Project: Alterations & Additions to Existing Lodge

Clancy Alpine Lodge
21 Plum Pine Road, Smiggin Holes NSW 2624
Lot 180 DP756697

PREPARED FOR: CLANCY SKI LODGE C/- ROBERT MATHER
PREPARED BY: MS | COMPLETE CERTIFICATION PTY LTD | BCA CONSULTING
REPORT NO: 21007
REVISION: 01

c) Fire Separation External Deck/woodstore.

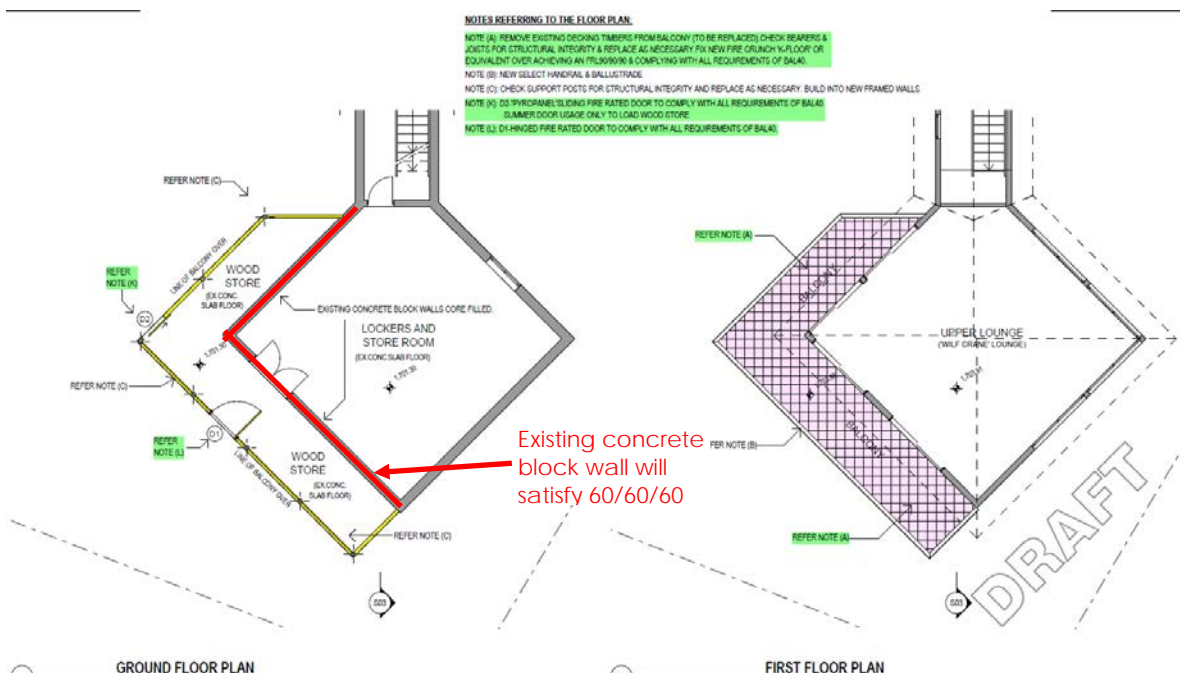
- The existing separating wall between the new store room and the locker storage are is constructed using core filled concrete block construction, which will satisfy the required FRL60/60/60 construction.
- The floor separating the new wood store and the balcony is required to achieve FRL30/30/30 or RISF 60.

Fire Crunch K-Floor is proposed and will achieve FRL90/90/90.

Proposed Managers Flat – Bed Room Addition

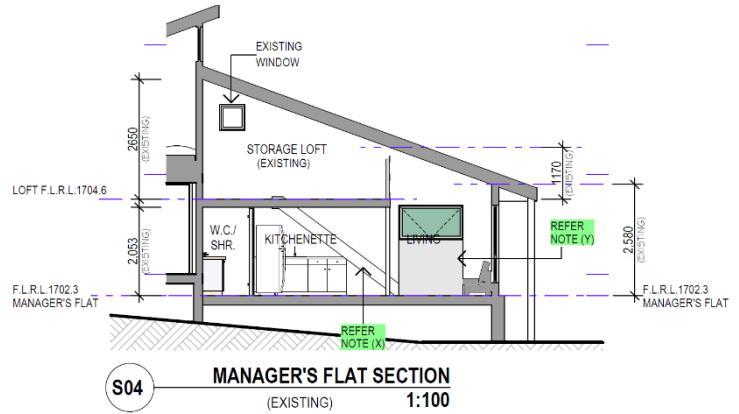
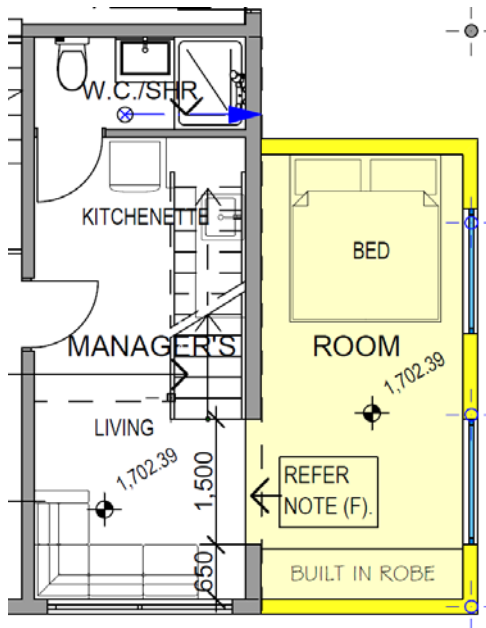
Existing wood store to be removed and reconstructed as managers bedroom.

Existing stair and loft to remain. (Balustrade to be made compliant)

New opening to be created in existing external walls to create manager bedroom.

Enclosure of Area Under Existing Deck to Create Wood Store.

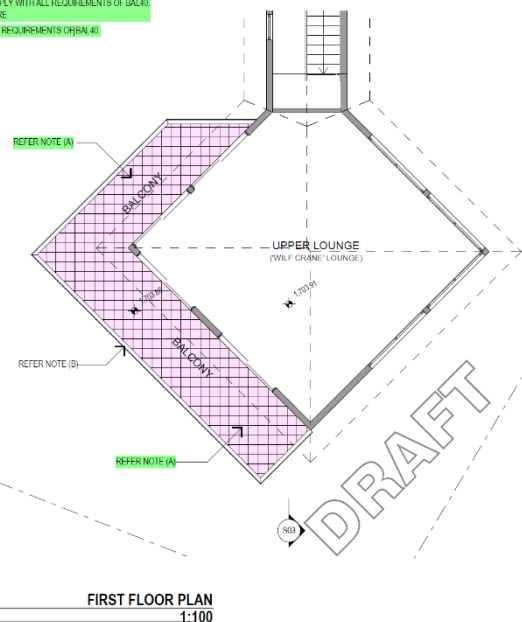
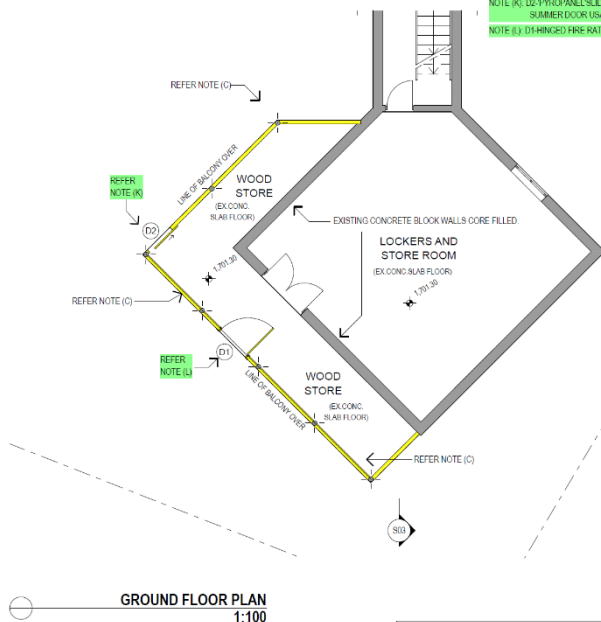
The floor separating the storeys must have

- An FRL30/30/30 or
- have a fire-protective covering on the underside of the floor, including beams incorporated in it and around the column if the floor or column is combustible or of metal;

- Core filled block wall and concrete floor slab.
- **Note: Latch to be removed and door open inward signage to be provided.**
